**Appendix A: Bridge Rehabilitation and Reconstruction
Alternatives**

Re : Bridge Rehabilitation - H&C Response to Comments
Job No. : J9P0436, J9P0437 and J9P0438
Route : 19
County : Shannon
HCI No. : 10180-00

Re : Bridge Rehabilitation or Reconstruction Alternatives
Environmental Impact Study, Bridges G-804A, J-420, H-79
Rte 19, Shannon County

Bridge Rehabilitation or Reconstruction Alternatives

REHAB. WITH P/S GIRDER - ELEVATION
ROUTE 19 SINKING CREEK BRIDGE
Shannon County

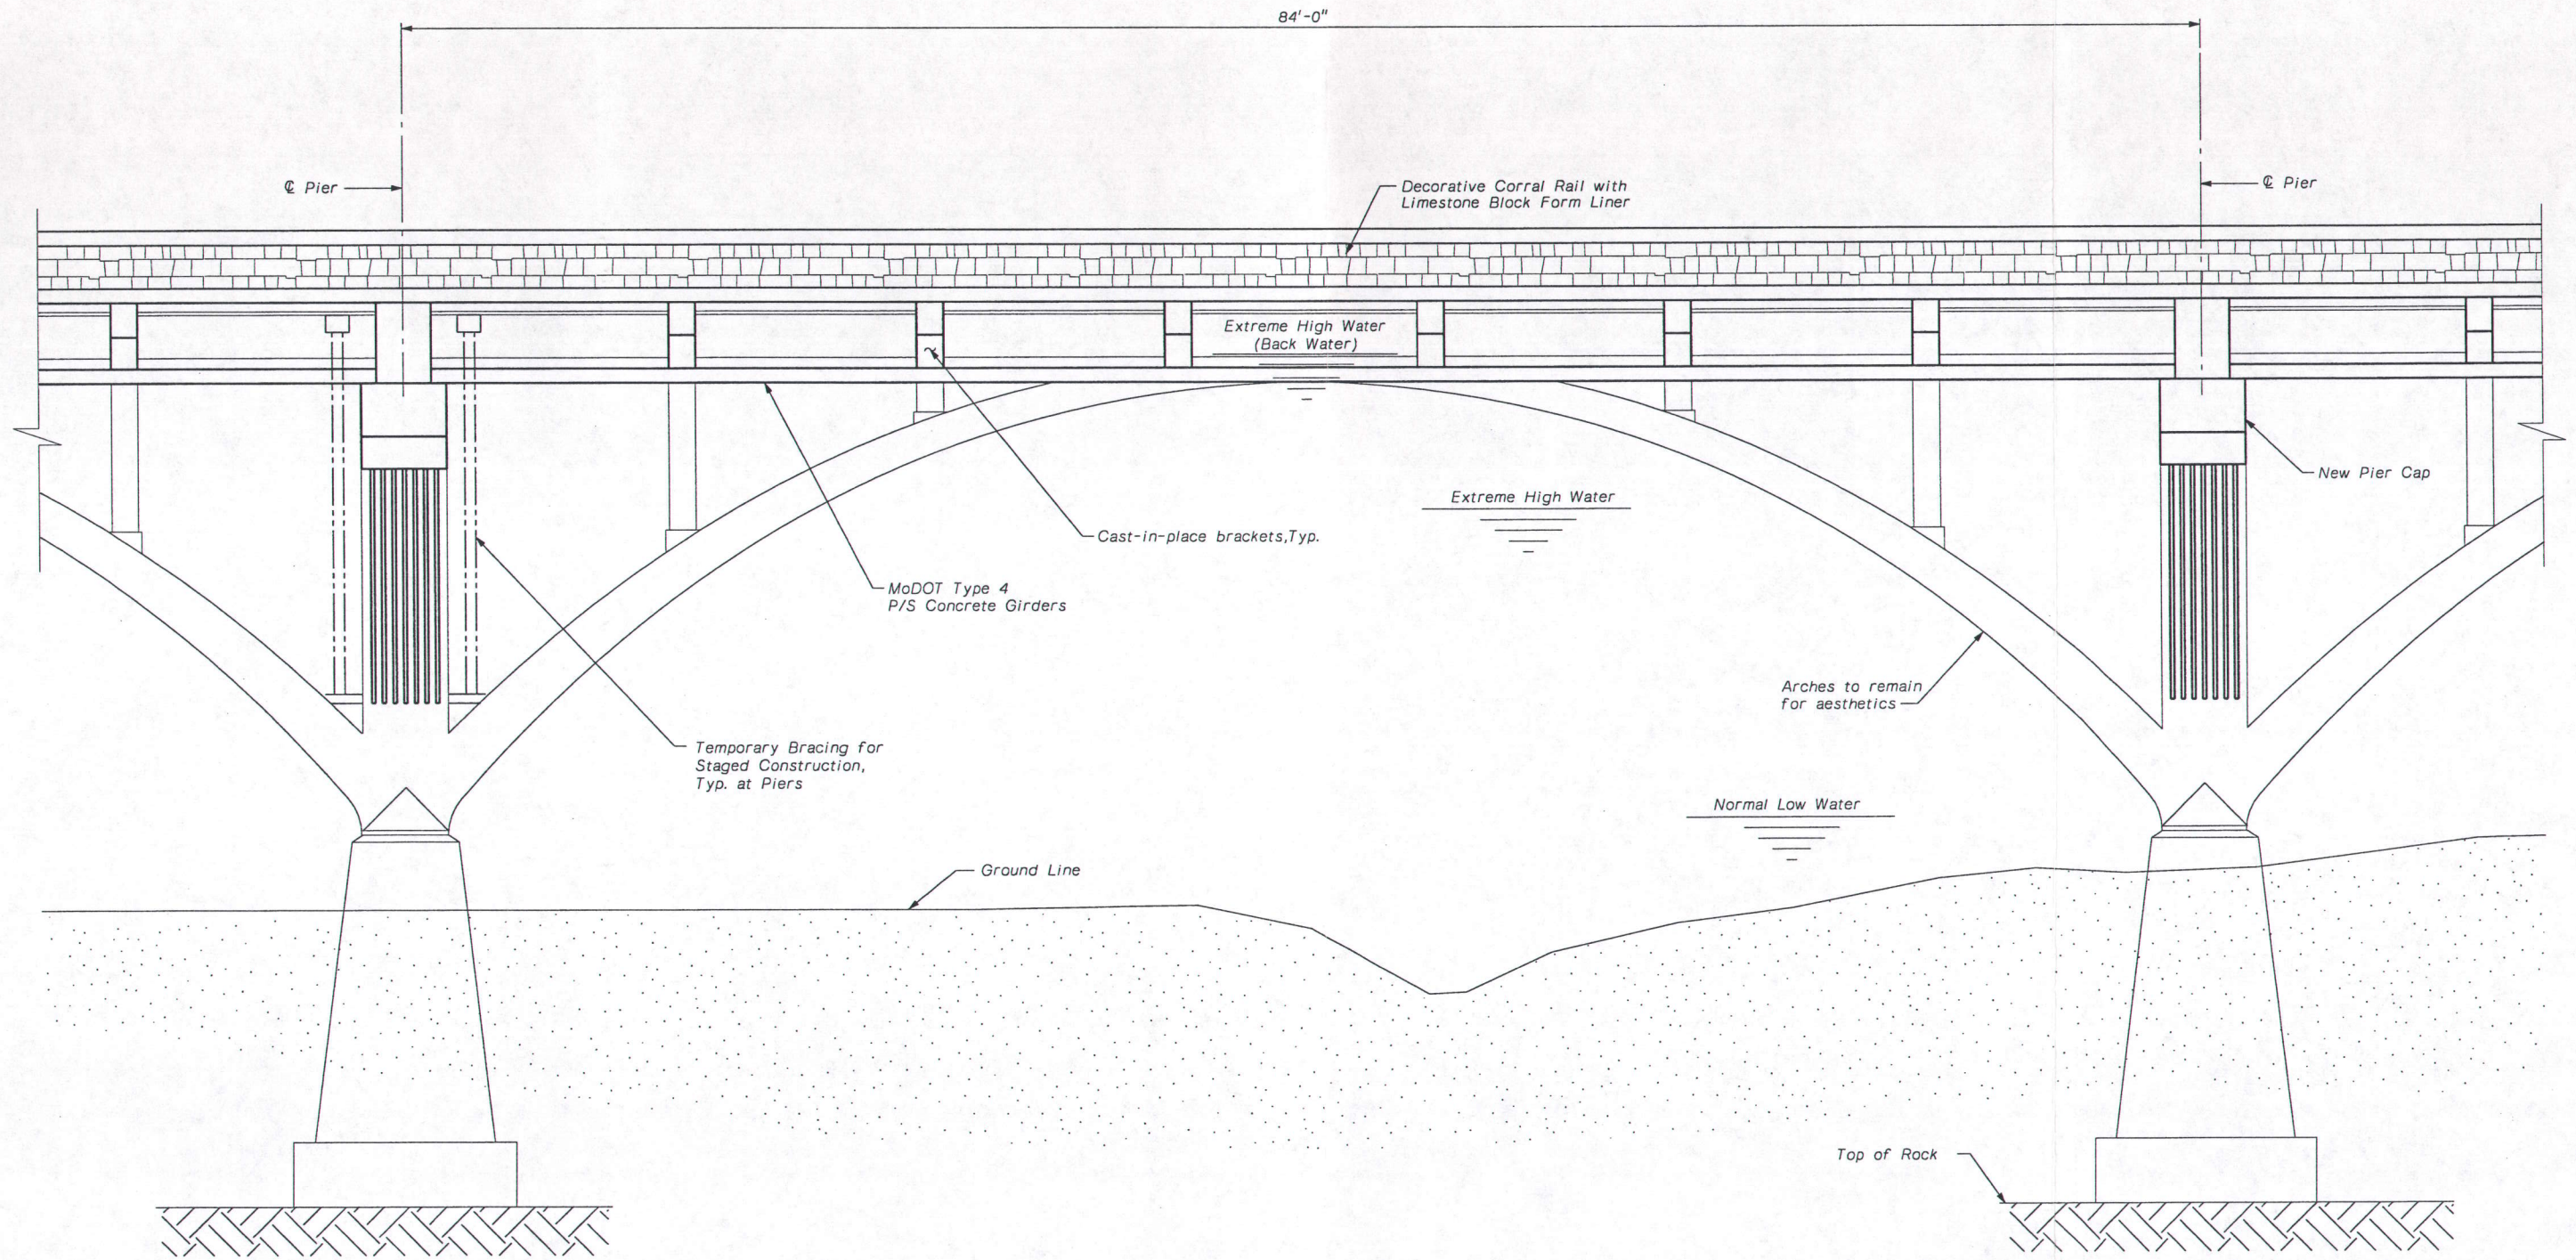
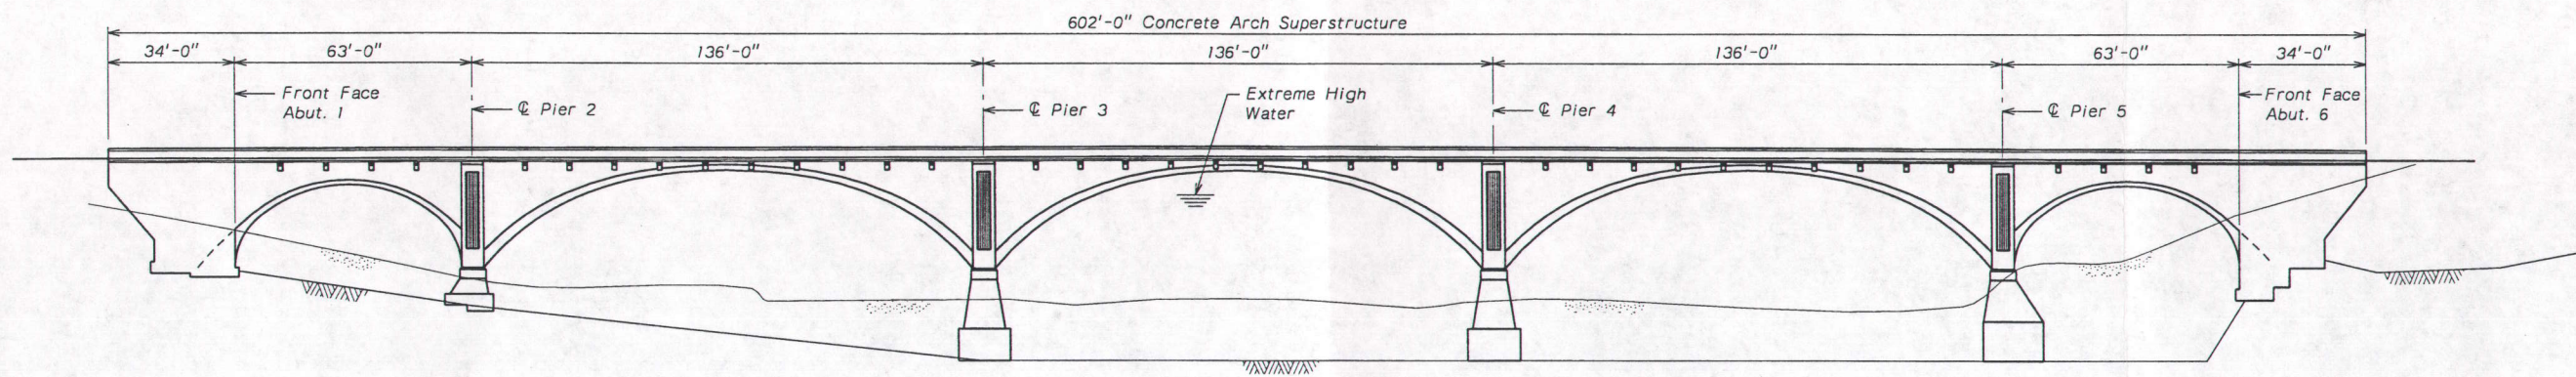
- The existing piers will be used to support a new cap and superstructure for the P/S Type IV replacement option at Sinking Creek. The parallel flange widening at the Current River (Br. G-804) will reuse the existing piers in conjunction with new piers adjacent to the existing.

- Our preliminary analysis utilized 3'-9" MoDOT Type IV prestressed girders with 0.6" diameter strands and an $f'c = 8$ ksi. The standard section dimensions would not need to be modified for these span lengths. This depth was preferable to minimize grade raise.

- Complete replacement alternative at Sinking Creek was assumed 1 ft. above extreme high water shown on existing bridge plans. Rehabilitation alternate will have extreme high water approximately one foot up on the girder. Elevation of girder for the rehabilitation is controlled by the arch geometrics.

REALIGNMENT SPAN LAYOUTS
ROUTE 19 CURRENT RIVER BRIDGE
Shannon County

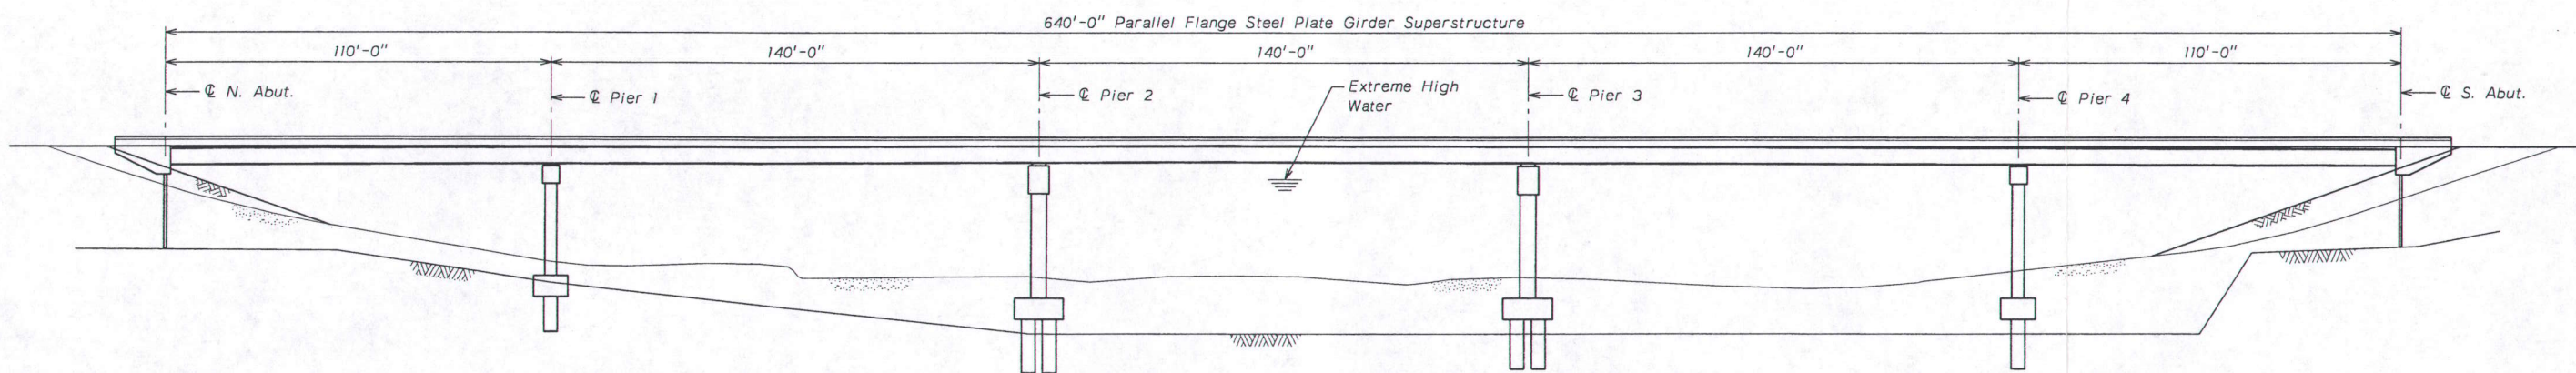
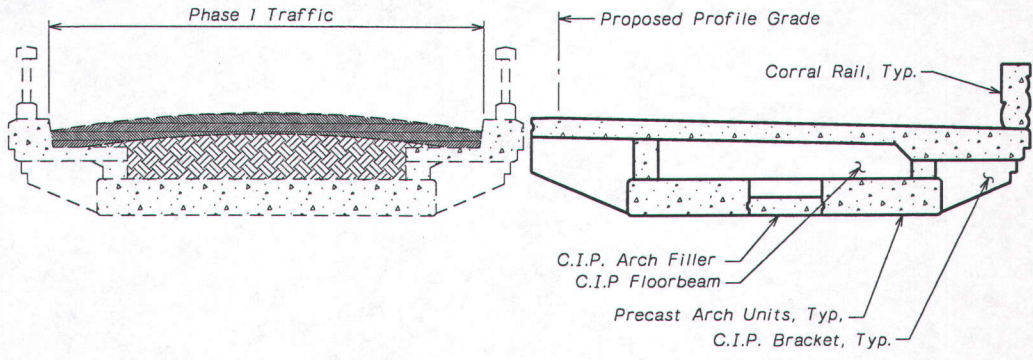
- A MoDOT Type 7 Girder for complete replacement was considered. Use of 130 ft. long, 60 ton girders was not further developed due to girder transportation concerns for the long girders on Rte 19 and large crane requirements to set the heavy girders. An alternative with type 6 girders (75-75-90-90-90-90-65-65) added three additional piers in the channel and was not further developed.

- Haunches at the segmental bridge have been reduced from 15' to 12' at the piers to minimize channel obstruction. A design exception will eventually be required. The new layout significantly reduces the channel obstruction compared to the existing bridge. A design exception may also be required for the 500 ft. radius curves that will be used at each end of the bridge.
